ENCLOSURE 1

MFN 05-133

Responses to DSS-CD TRACG LTR RAIs

Non-Proprietary Version

Figure 4-1. Convective Terms at a Junction Between Components Using Different Numerical Methods.

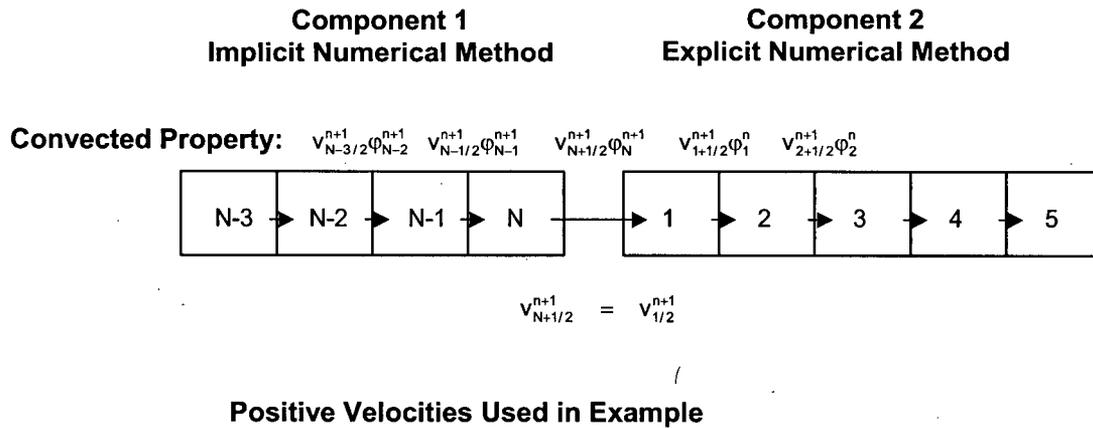
Is the numerical method selected on a component by component basis? If so how are the inconsistencies between numerical methods handled to ensure conservation of mass and energy at boundaries between explicit and implicit components?

The numerical method is selected on a component-by-component basis. For applications to stability the explicit integration is used for the channel component, other components use the implicit numerical method. When a component using an implicit numerical method is connected to a component using the explicit numerical method, the new time step fluid properties are convected between the two components. Thus the component using the implicit numerical method is fully implicit for all nodes. The explicit component is fully explicit for all nodes except for a node connecting to an implicit component, which will use a mixture of old time step and new time step properties in the convective terms. Old time step properties are used in the convection to other cells in the explicit component and new time properties are used in the convection at a face connecting to an implicit component. See also Figure 4-1, that shows the choice of old time step property " ϕ^n " or new time step property " ϕ^{n+1} " for the convective terms for a combination of two components using different numerical methods. With this approach mass and energy balances are conserved.
